DEVELOPMENT APPLICATION NO: DA19/0875

URBIS RESPONSE TO PENRITH CITY COUNCIL REQUEST FOR ADDITIONAL INFORMATION – 27TH APRIL 2020

Response to RFI Relating to Visual Impacts

NEPEAN GARDENS, WALLACIA, NSW

VP C : 115 PARK ROAD - REAR, LOOKING NE | 3D MODEL - FULL MONUMENTAL WITH 1500MM HEADSTONE (NO PROPOSED VEGETATION)

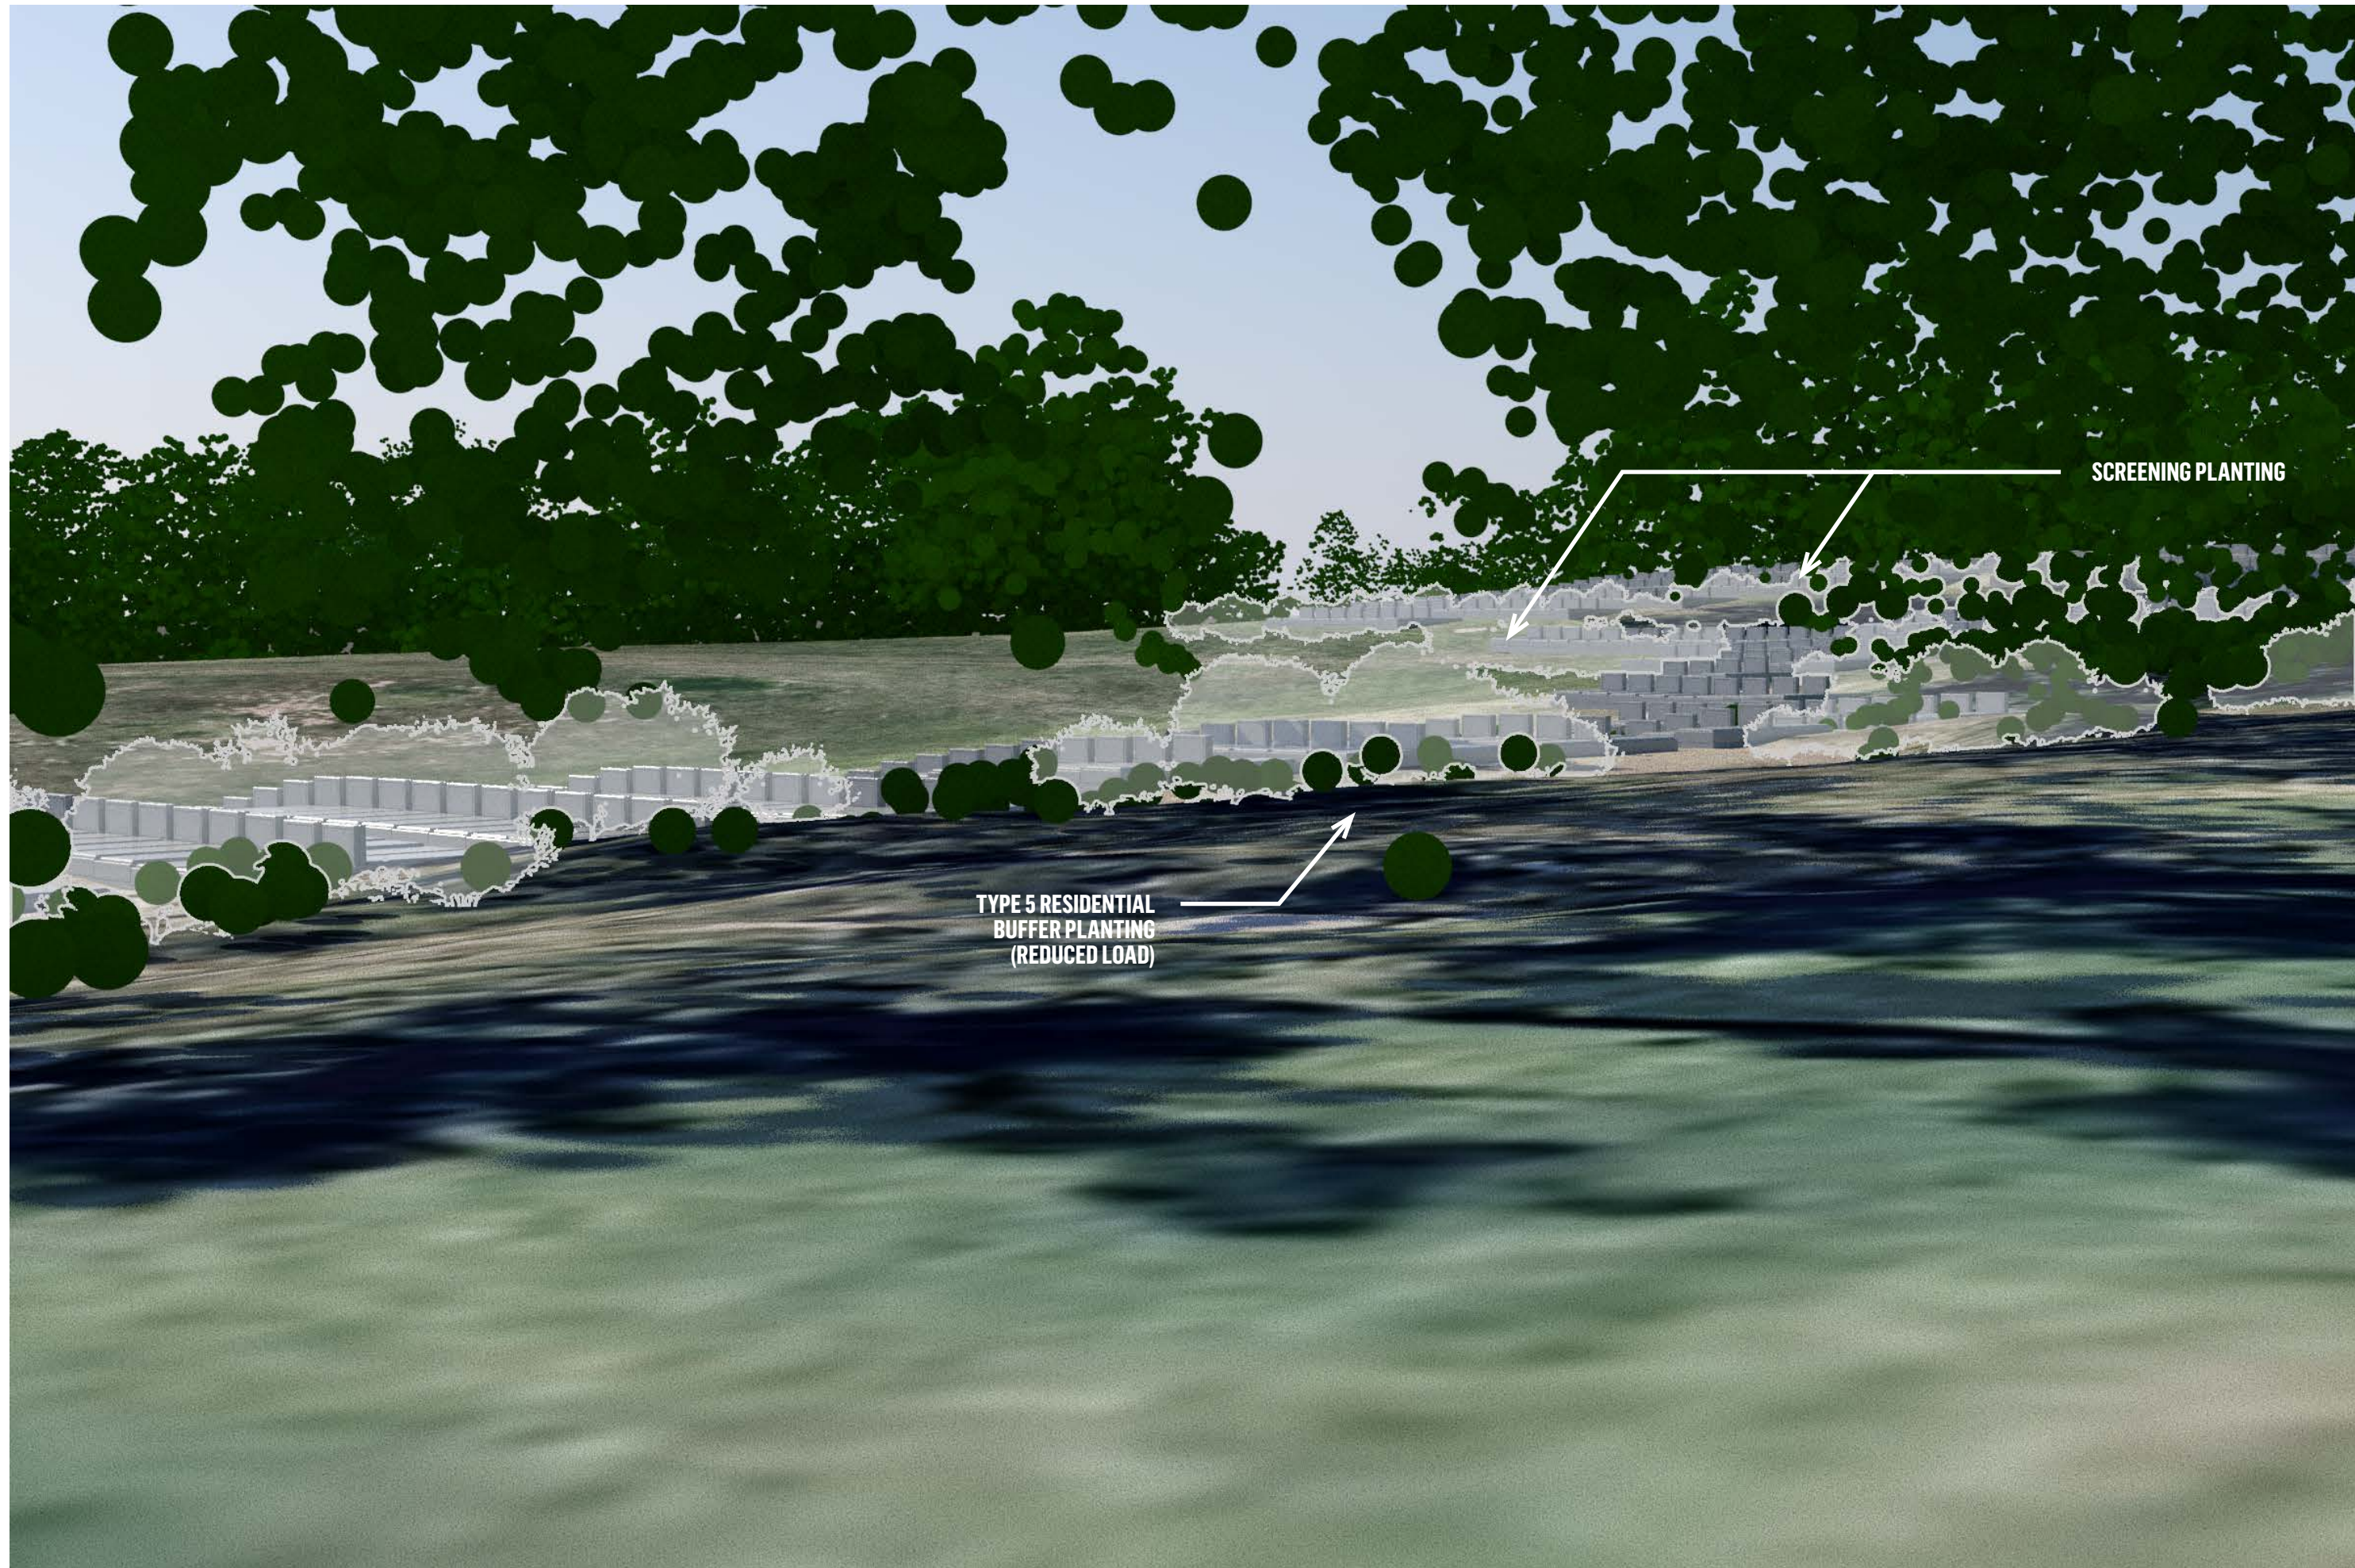
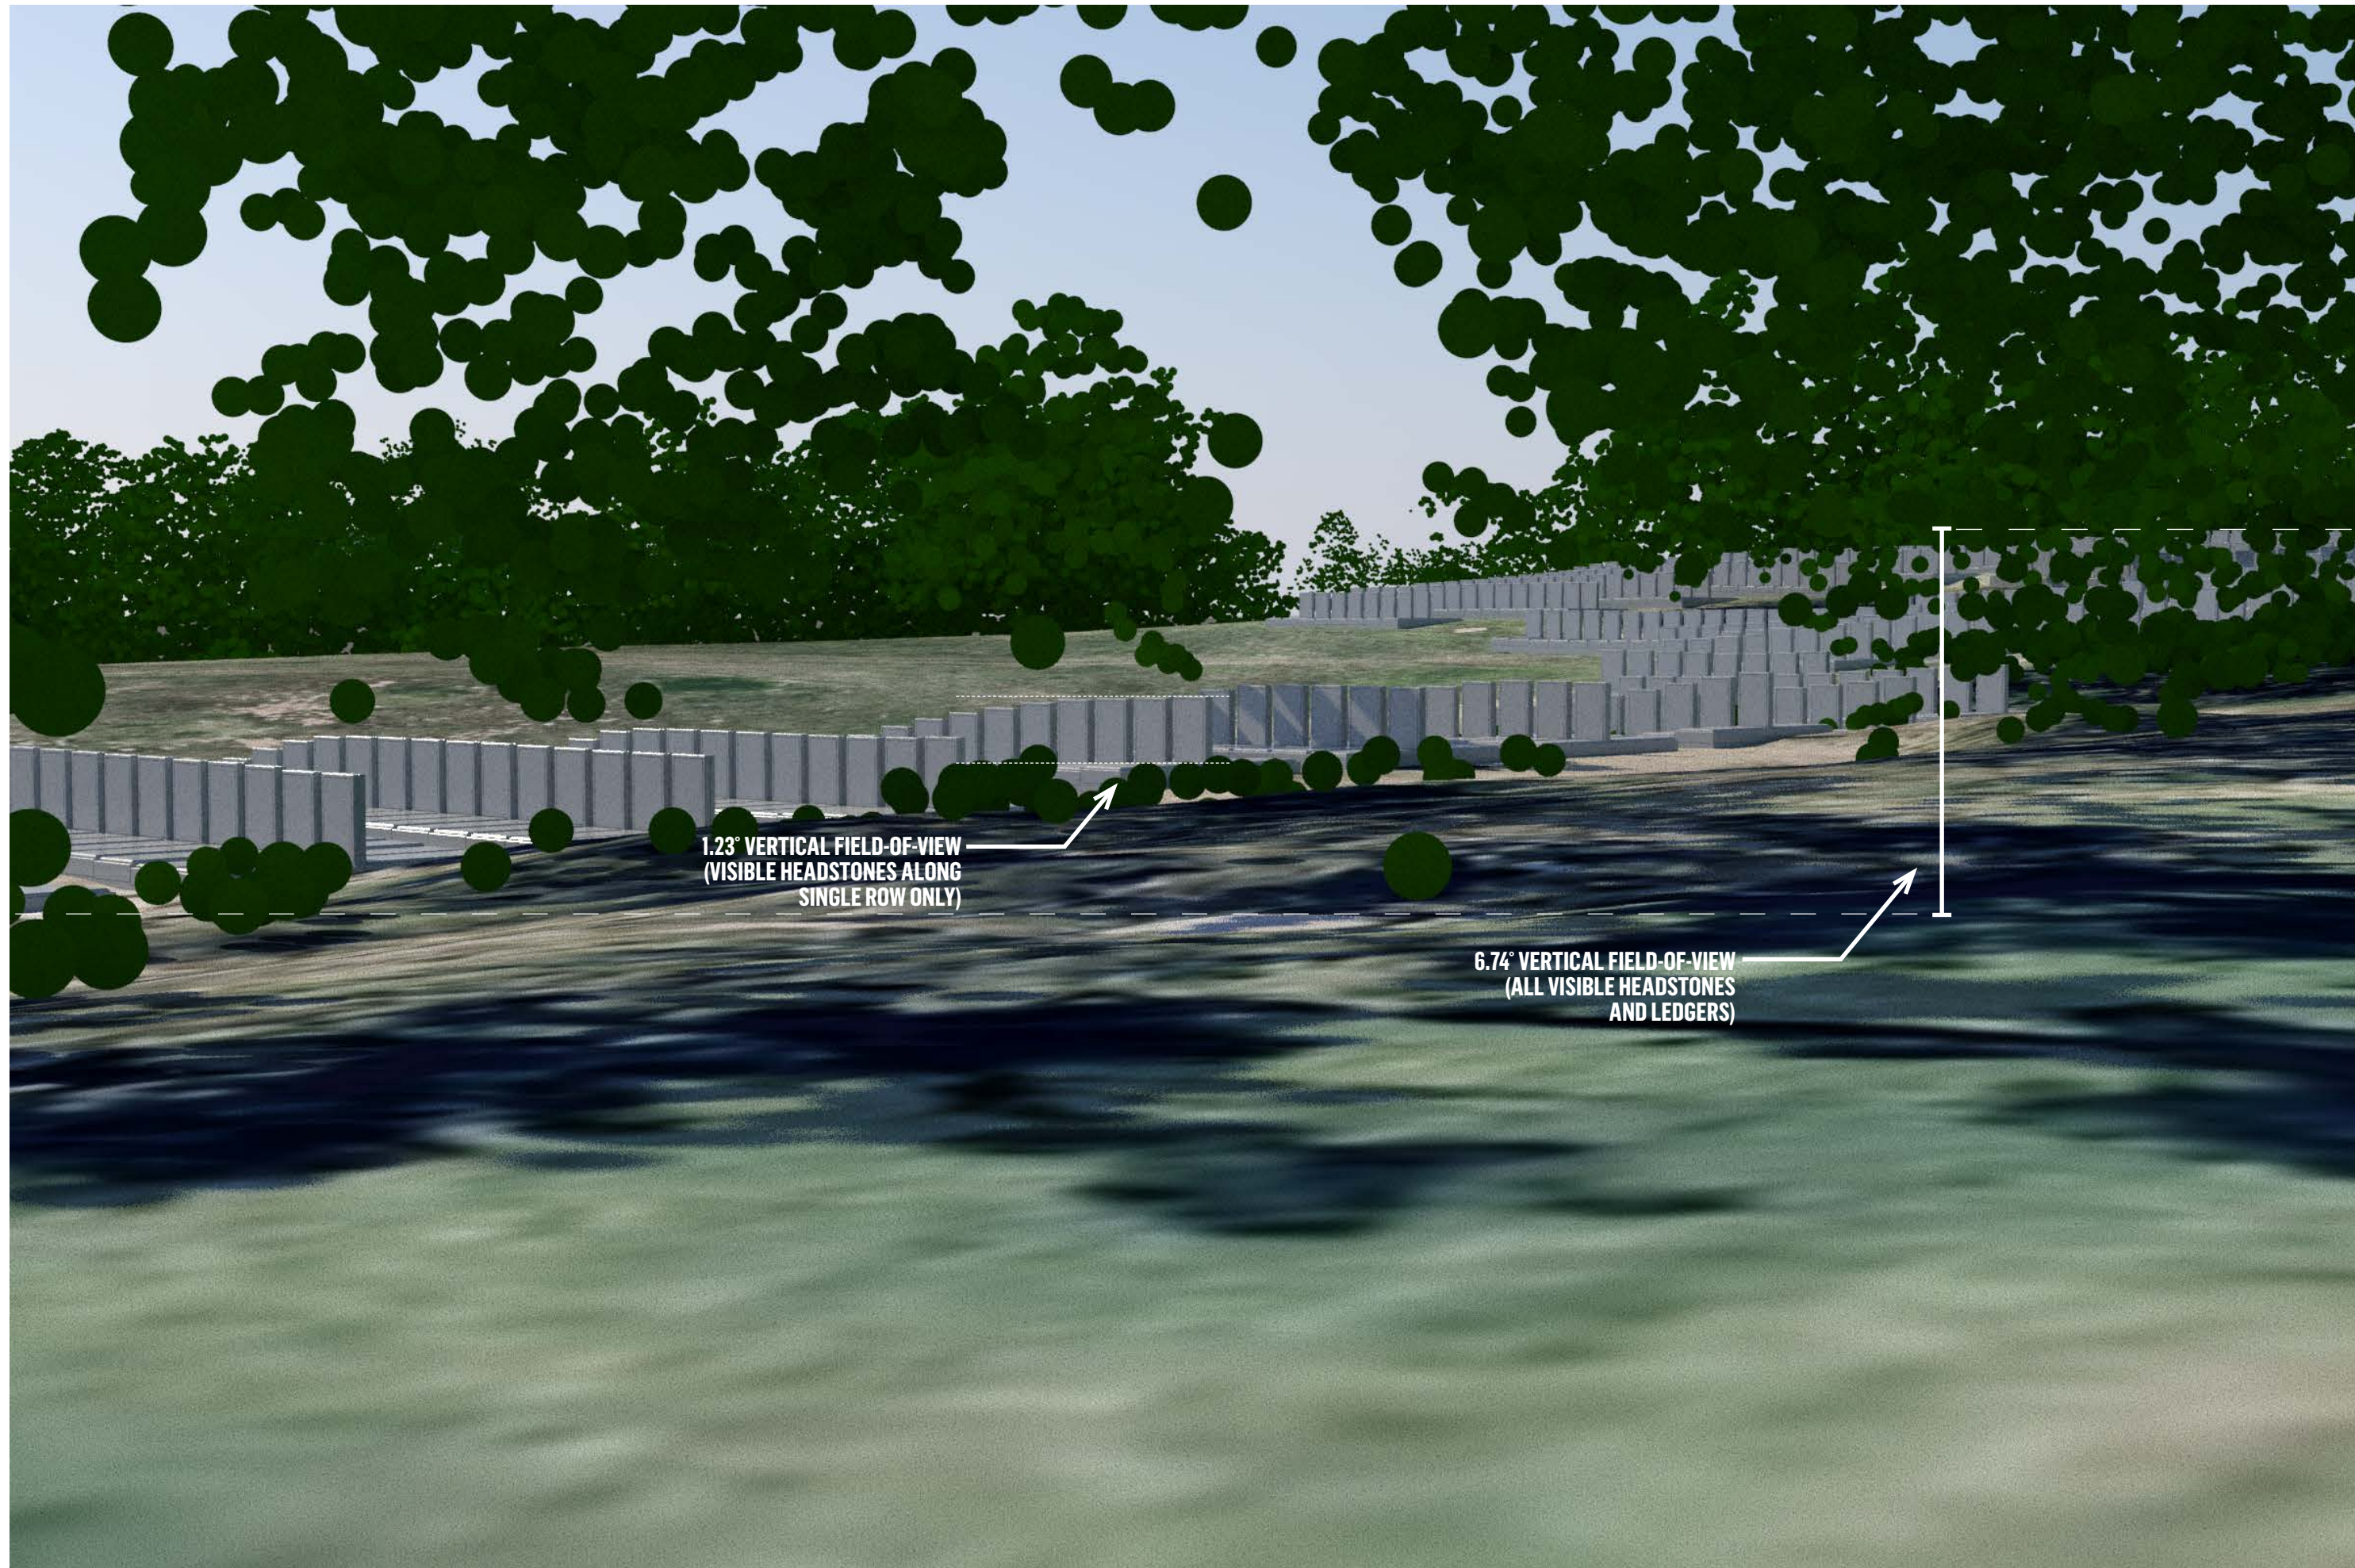
(h) The proposal for Type 3 - 1.5m high memorial head stones is likely to impact poorly on views from neighboring rural residential properties. A response is requested as to why memorial headstones should not be limited in height to 600-800mm, so as to be less visible. The impact of the proposal for Type 4 - Full monumental installations needs to be assessed and in this regard, further detail is to be provided as to the allowable dimensions and locations for this typology. A view analysis or montage may be required.

- VP A – 0.19° vs 0.52°
- VP B – 0.53° vs 1.14°
- VP C – 0.76° vs 1.23°

In all views, the buffer landscaping is highly effective at ameliorating views from surrounding areas. Given the headstones are only 1.5 m in height, buffer planting proximate to viewing location is highly effective in screening views within a relatively short period of time. Post planting, the landscape will gradually reduce views of the monuments. The computer simulations demonstrate that after 5 years, the landscaping will be of a height to effectively screen views to the tops of the monuments.
